**DATE:** December 21, 2017

**TO:** Santa Fe County Planning Commission

**FILE REF.:** CASE # V17-5520 Oreo, LLC Variance

Oreo, LLC., Applicant, Design Enginuity (Oralynn Guerrerortiz) Agent, request a variance to the requirements set forth in the Sustainable Land Development Code (SLDC) of Chapter 7, Table 7-13: Rural Road Classification and Design Standards (SDA-2 and SDA-3) to allow a 250 ft. section of South Summit Drive to exceed 9% grade and a variance of Chapter 7, Section 7.17.10.7.8 Screening Requirements to allow existing 14 ft. retaining walls to exceed the (5) ft. height limitation.

**HIGH SUMMIT III - PHASE 2**

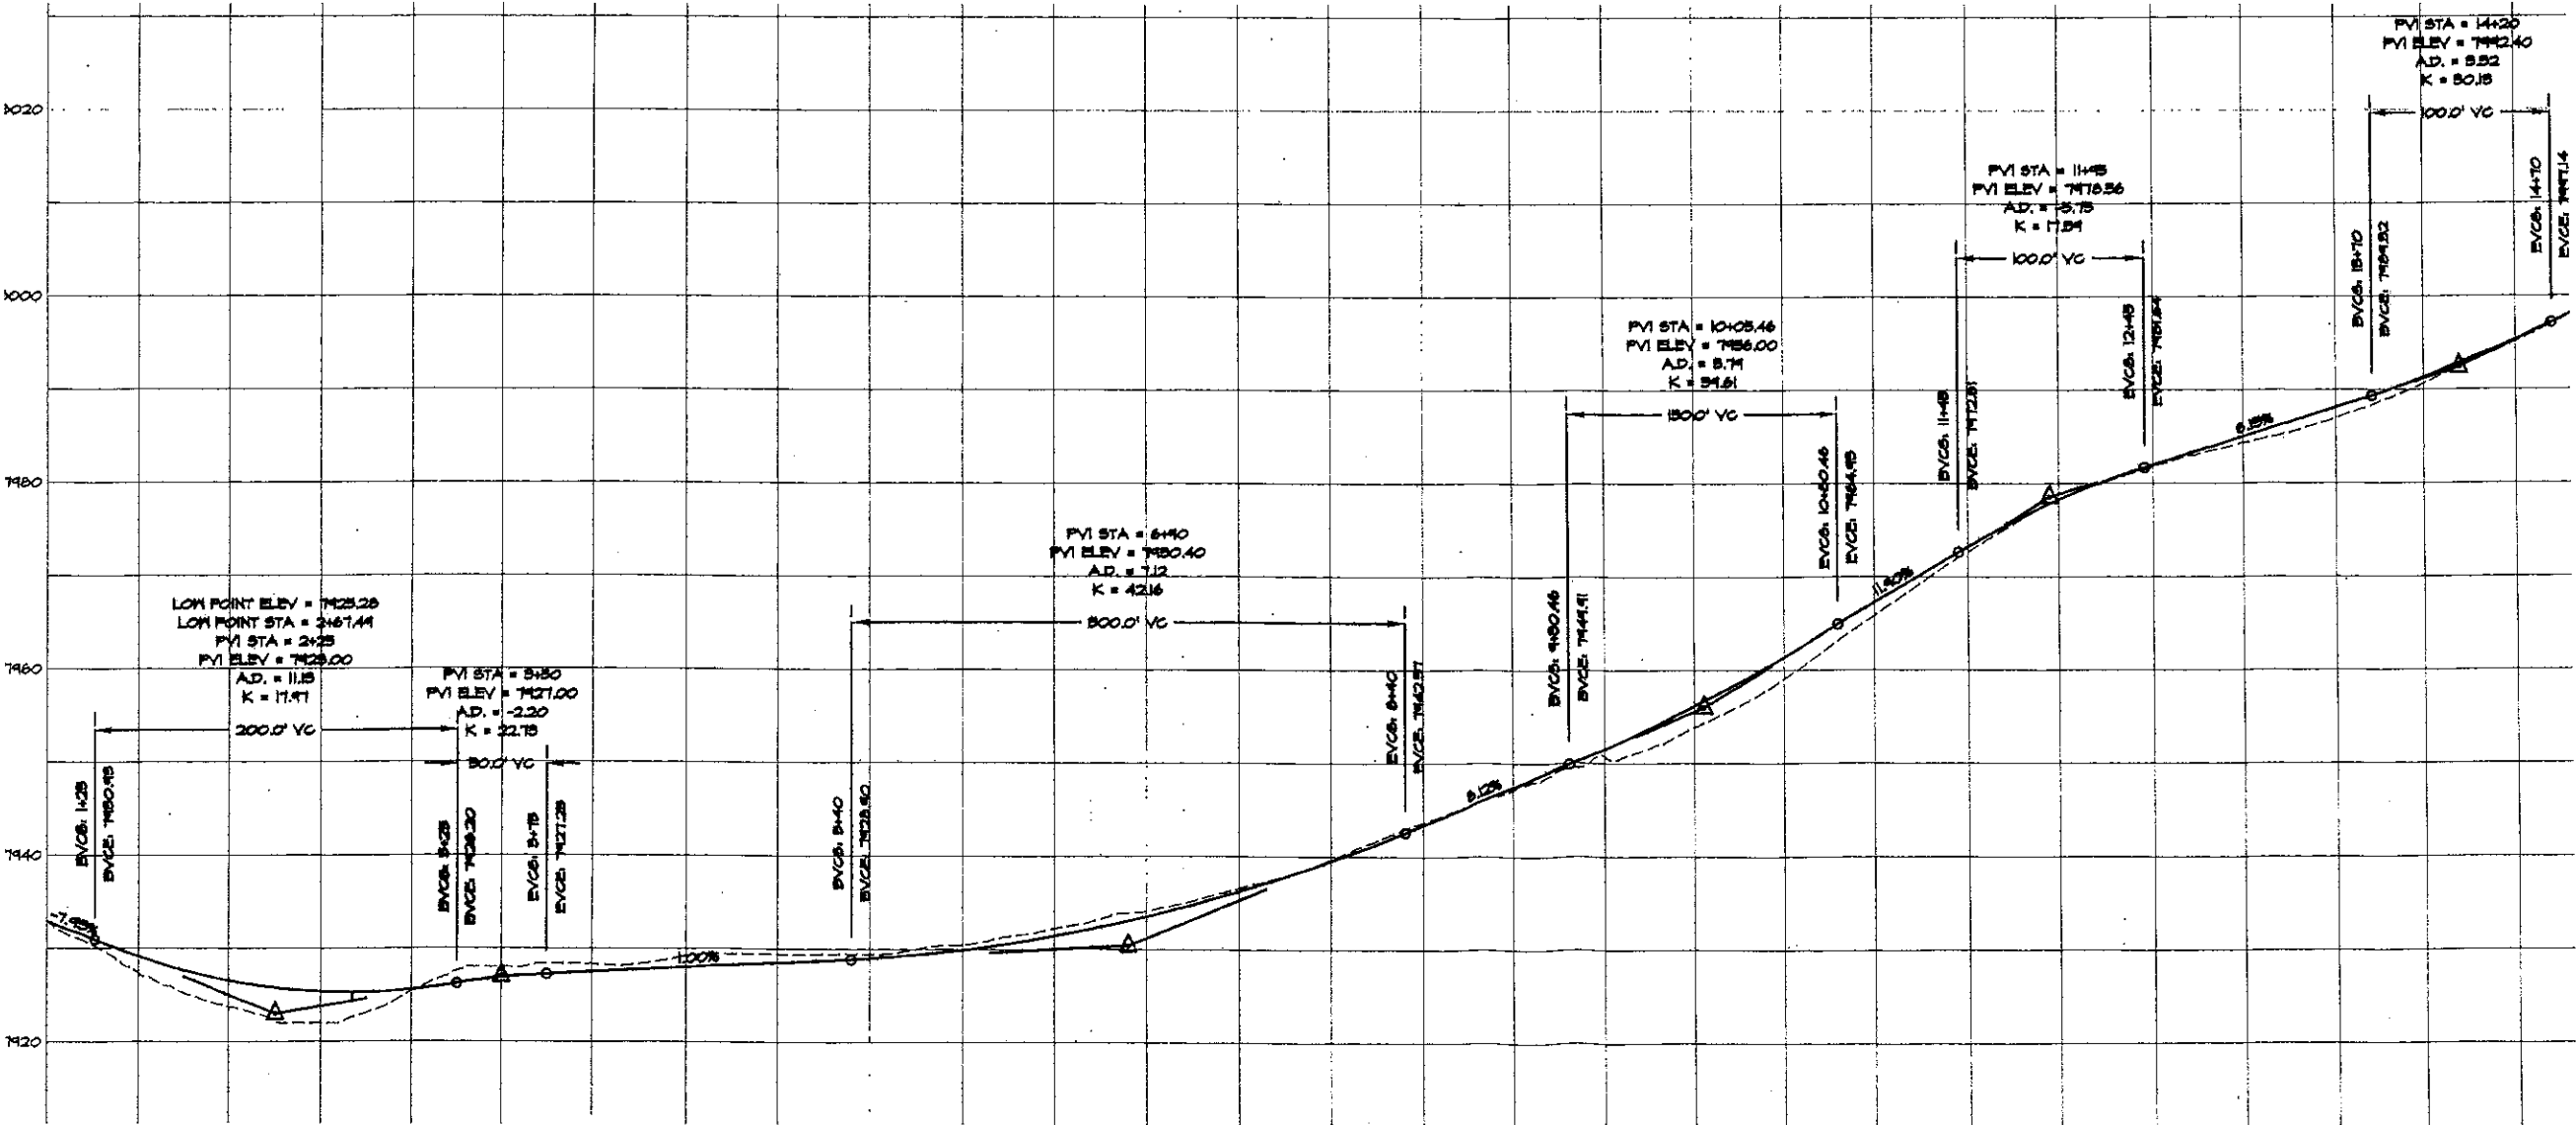
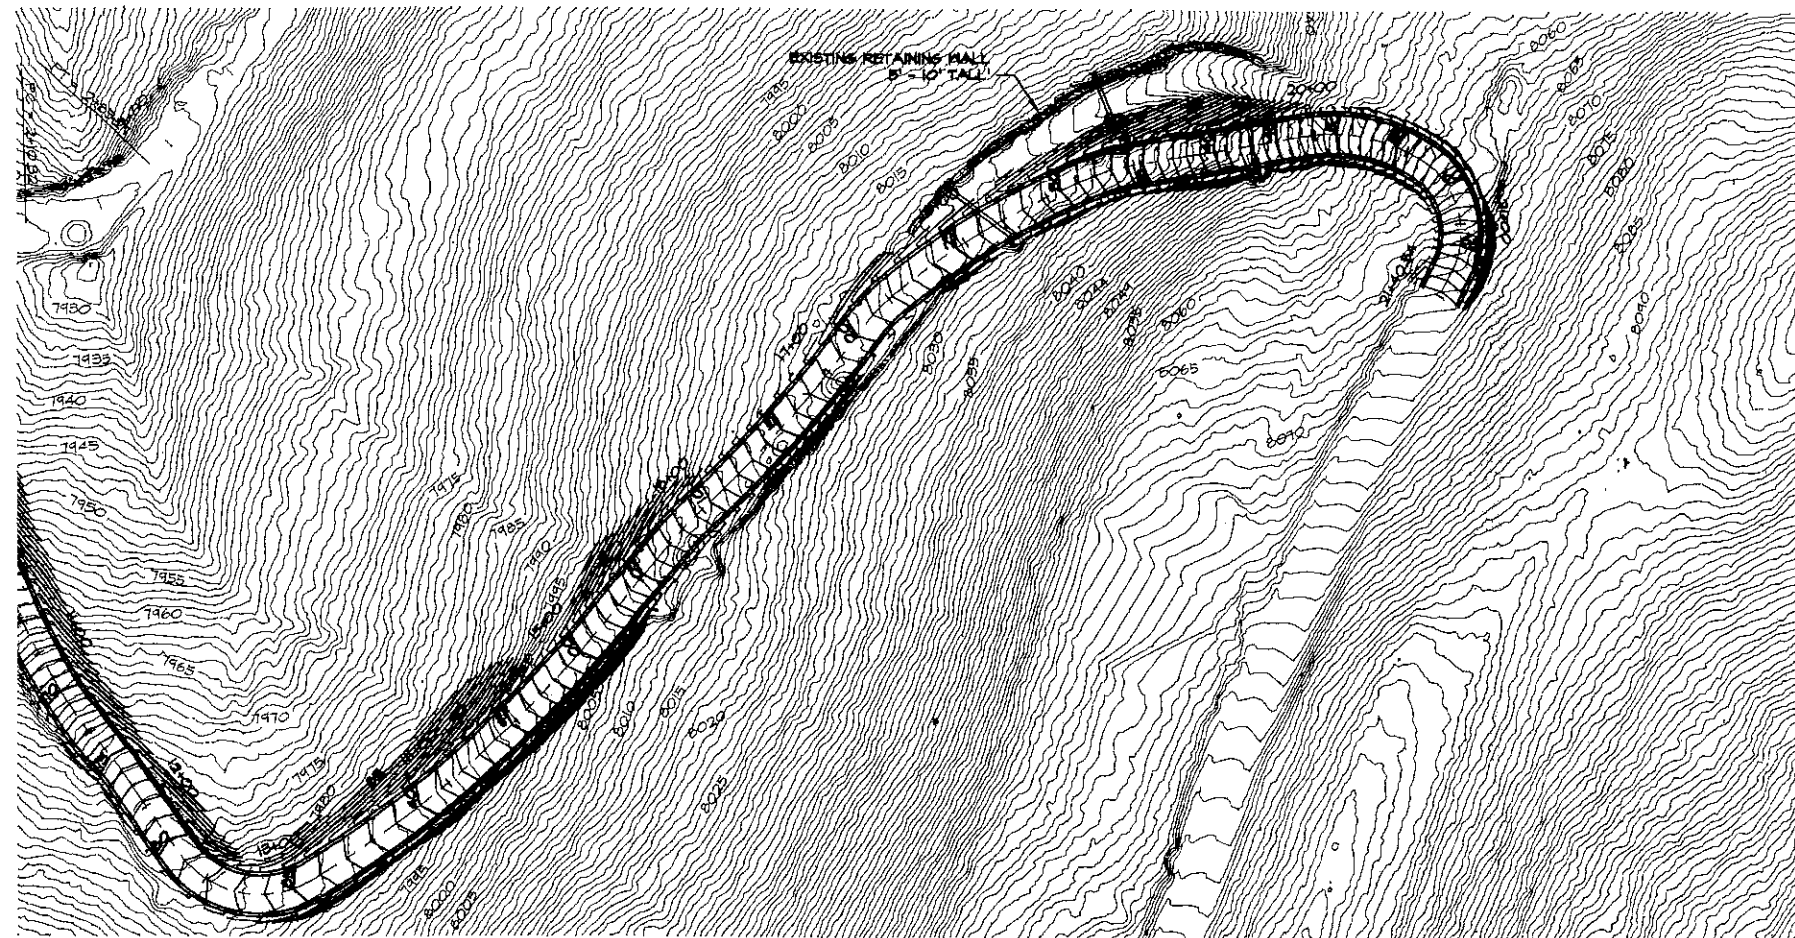
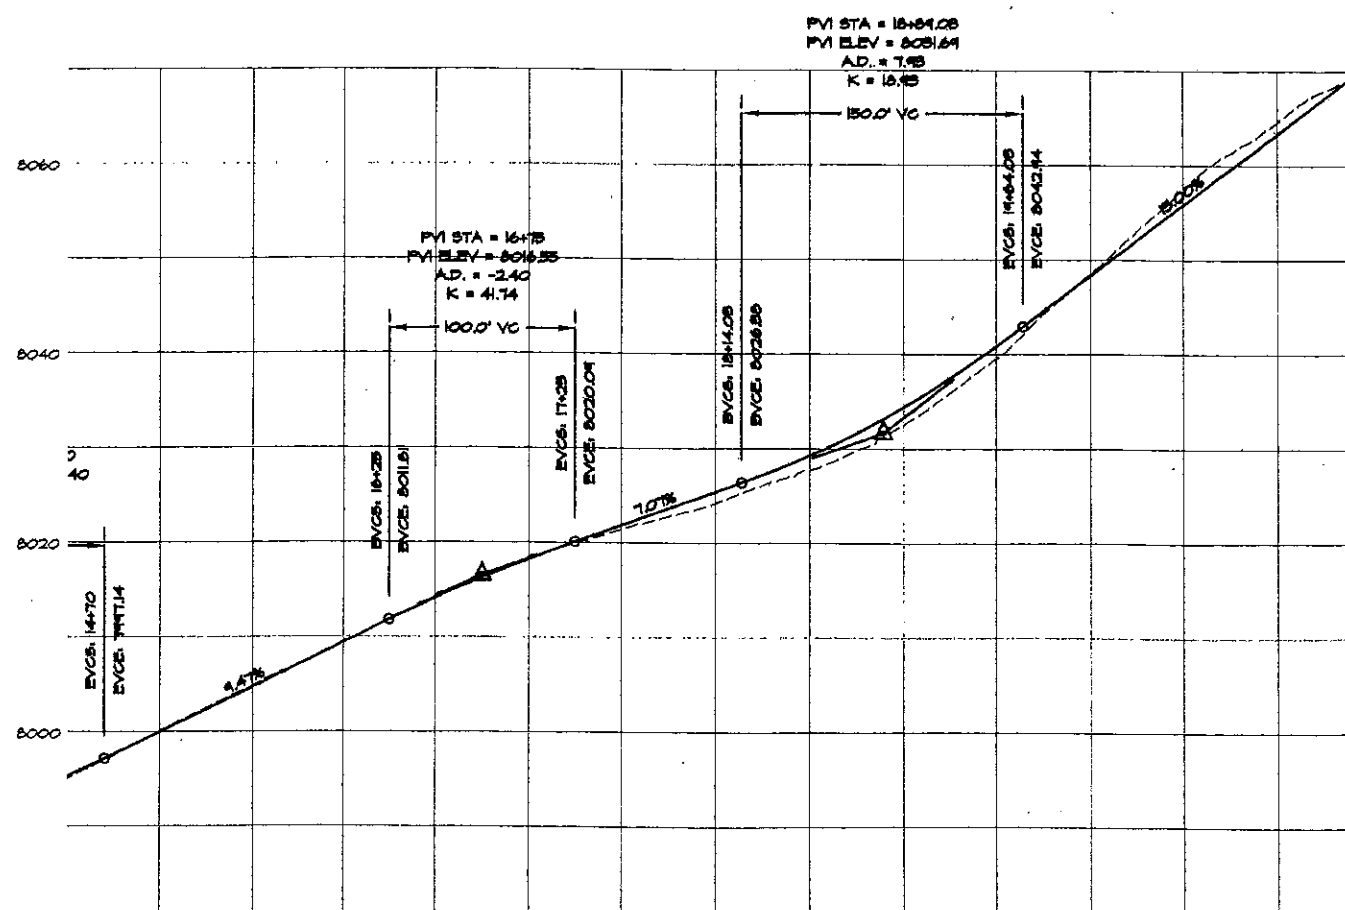
**Staff Response:** On the project site there are two 14 ft. retaining walls as indicated on the Plan and Profile (Exhibit 7). Staff has confirmed that leaving the existing retaining walls would have less impact to the terrain, less impact to existing vegetation and would minimize grading and fill to the terrain. The applicants engineer has stated that if the variance is approved to keep the retaining walls, the engineer would certify the retaining walls' structural integrity and ensure that the retaining walls were properly permitted. Chapter 7, Section 7.17.10.7.8 indicates that no retaining walls shall be greater than five feet 5 ft. in height. Staff has conducted a site visit and has determined that the existing 14 ft. retaining walls would be difficult to see from any roadway. The retaining walls are currently screened by existing vegetation to include large trees and shrubs. If the applicant were to modify these 14 ft. retaining walls to the current SLDC requirements of 5 ft., extensive grading and disturbance of slopes would have to occur, and a significant amount of vegetation including large trees and shrubs would have to be removed.

- 1. An engineer will certify the structural integrity of the retaining walls and ensure that the retaining walls are properly permitted.**
